SECTION 16 PLANNING APPLICATION

**PROPOSED TEMPORARY CONTAINER STORAGE YARD, CONTAINER VEHICLE PARK,
VEHICLE REPAIR WORKSHOP, LOGISTICS CENTRE, WAREHOUSE AND
OPEN STORAGE OF MISCELLANEOUS GOODS WITH ANCILLARY FACILITIES
AND ASSOCIATED FILLING OF LAND FOR A PERIOD OF 3 YEARS IN “AGRICULTURE” ZONE**

**VARIOUS LOTS IN D.D. 87
HUNG LUNG HANG, NEW TERRITORIES**

DSD Comment on DIA Report

DRAWING NUMBER
FIGURE 3

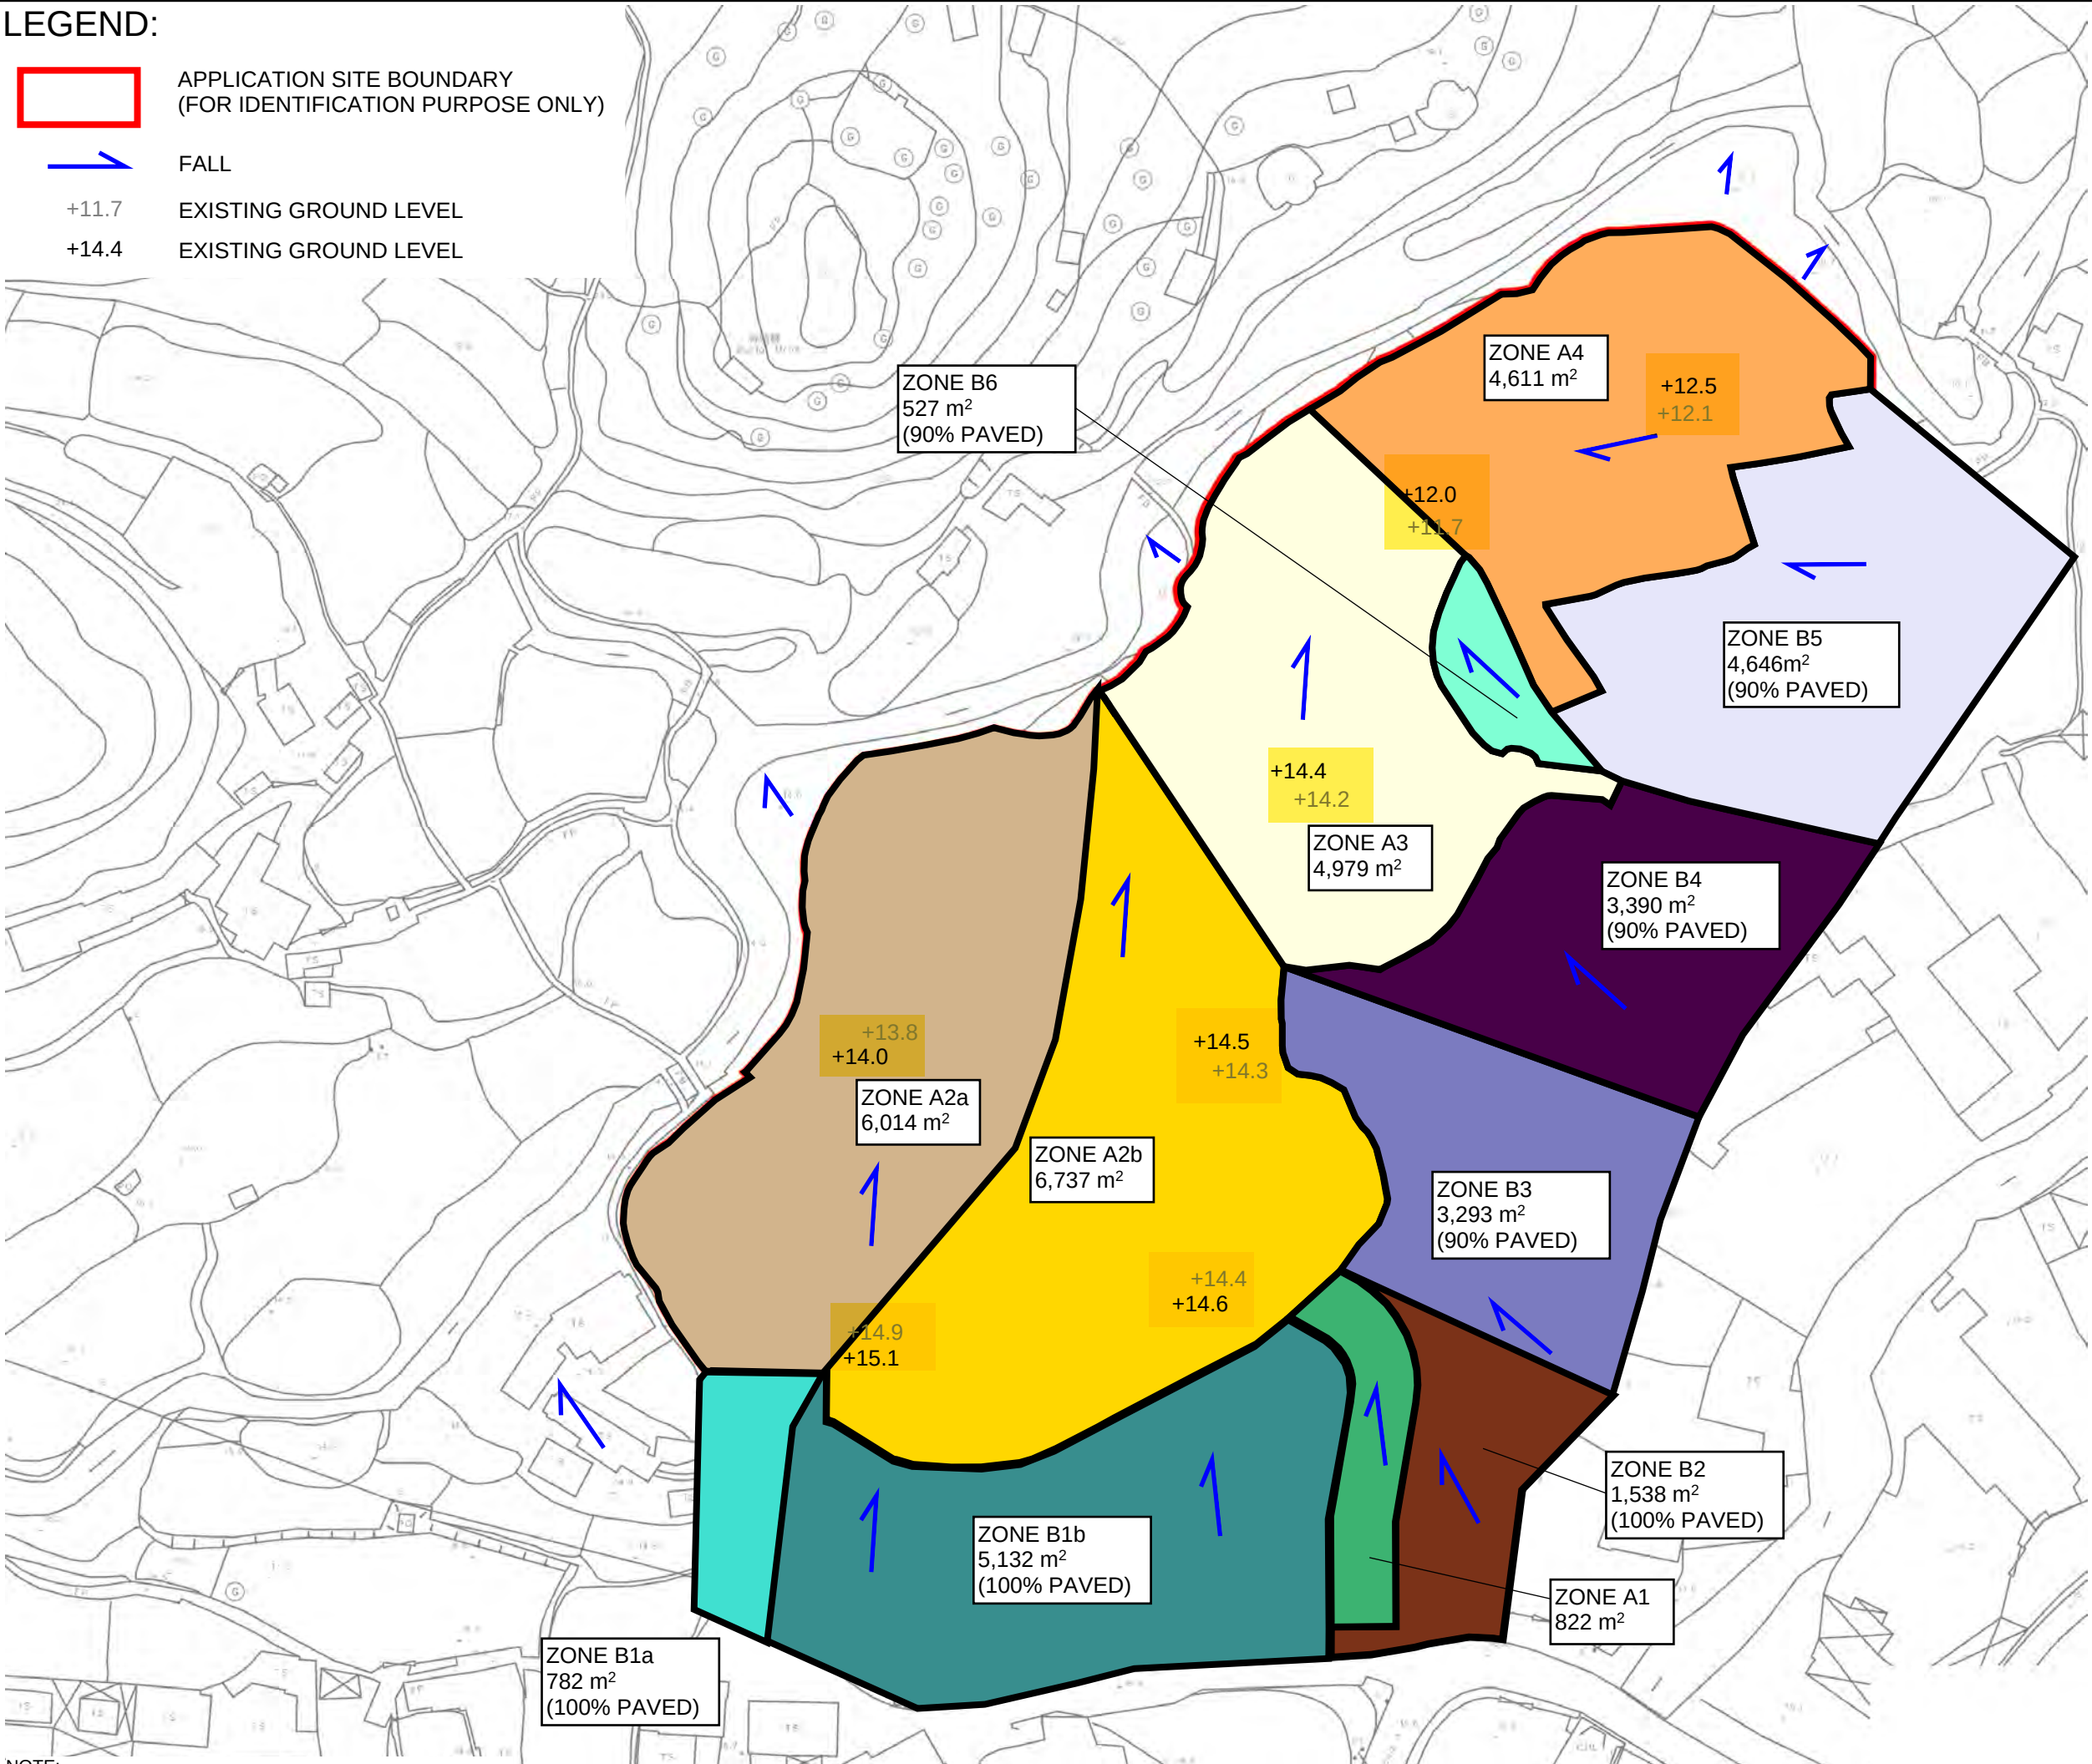
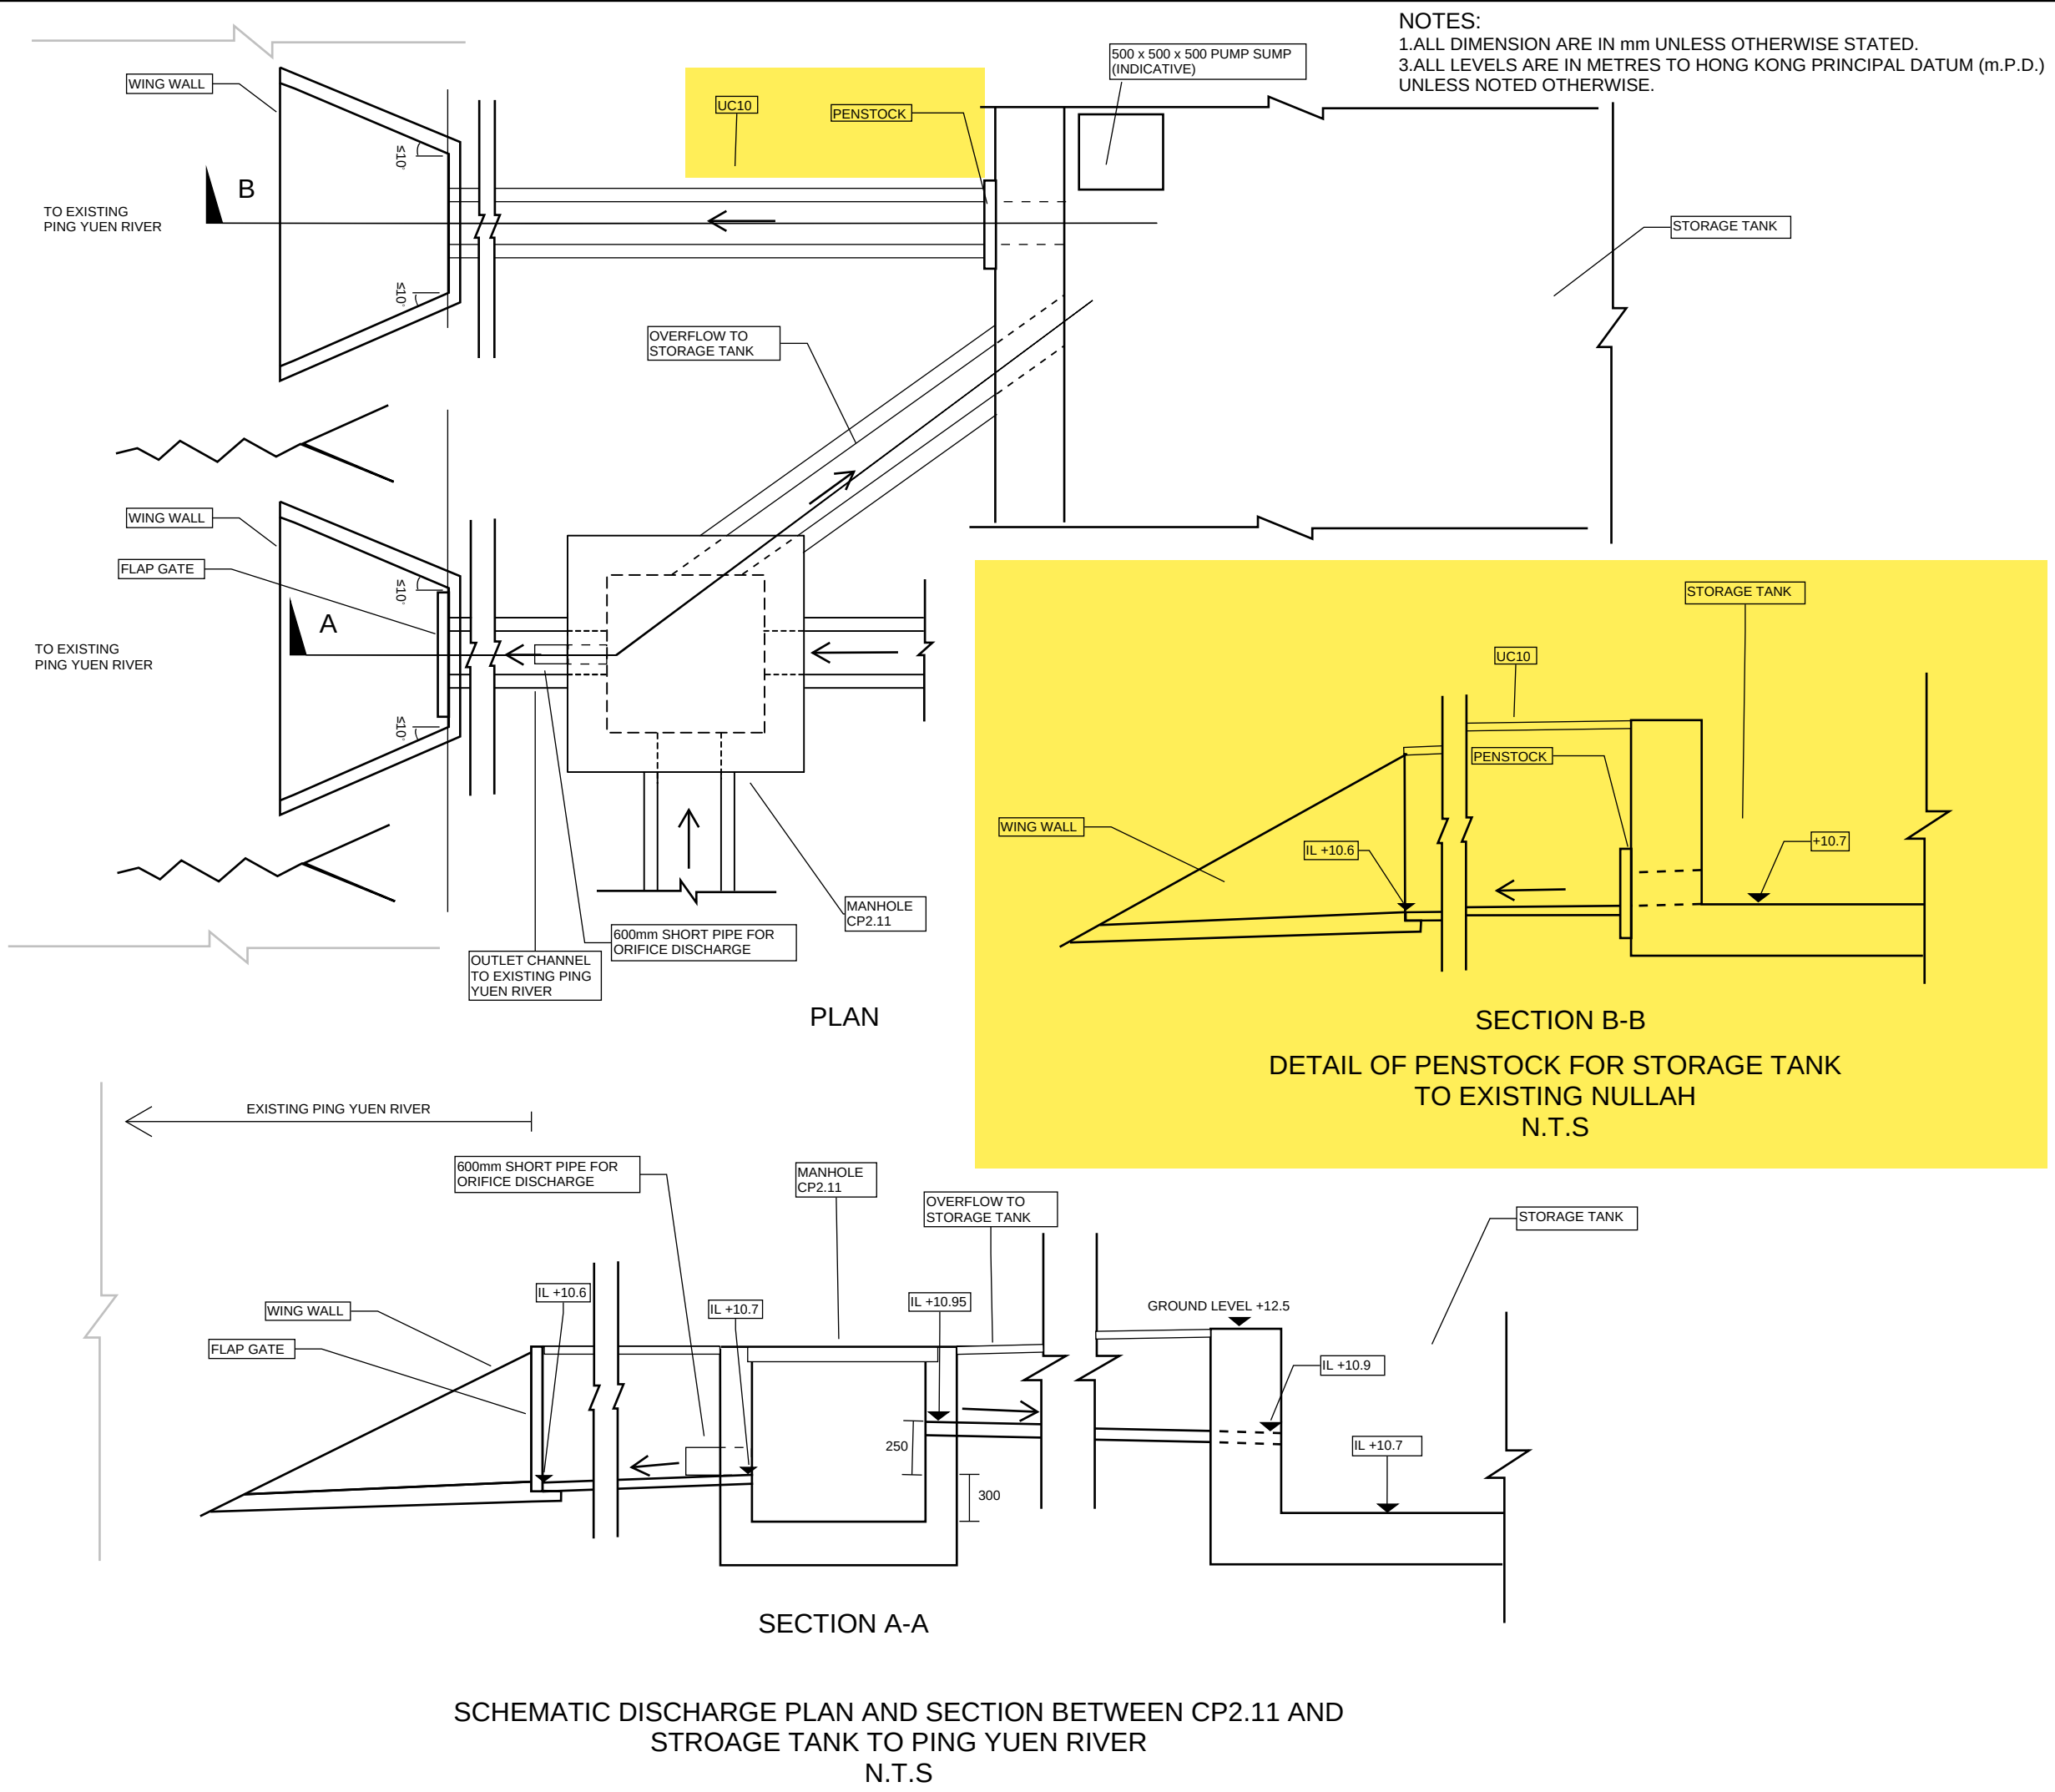
Item	Comments	Responses
1	Para. 3.1.3 (6): It appears that the 240 mins duration should be read as 120 mins.	Noted. Para.3.1.3 (6) is updated accordingly.
2	Figure 3 & Figure 5	
a	please advise the details at CP2.9 and clarify how the flow is distributed to the storage tank and downstream CP2.11;	The channel connecting from CP6.7 to storage tank is a overflow channel to allow more effective storage from channels to the tank. The channel invert level is added on Figure 3 for reference.
b	please advise the existing invert level of Ping Yuen River at the proposed discharge point;	Please note according to the CEDD, GEO Spatial Data, the invert level of Ping Yuen River at discharge point is about + 10.52 mPD.
c	please indicate the location of penstock at the plan view. A section view shall also be provided; and	Noted. Please refer to updated Figure 5 for location and section of penstock.
d	please review if the typical details in Appendix B can be applied to CP2.11, where the U-channel of 1050mm width will be connected to the catchpit; and	Note is added in Figure 3 "FOR CATCHPIT WITH CONNECTION CHANNEL LARGER THAN 900mm, THE STRUCTURAL DESIGN SHALL BE REVIEWED BY ENGINEER."
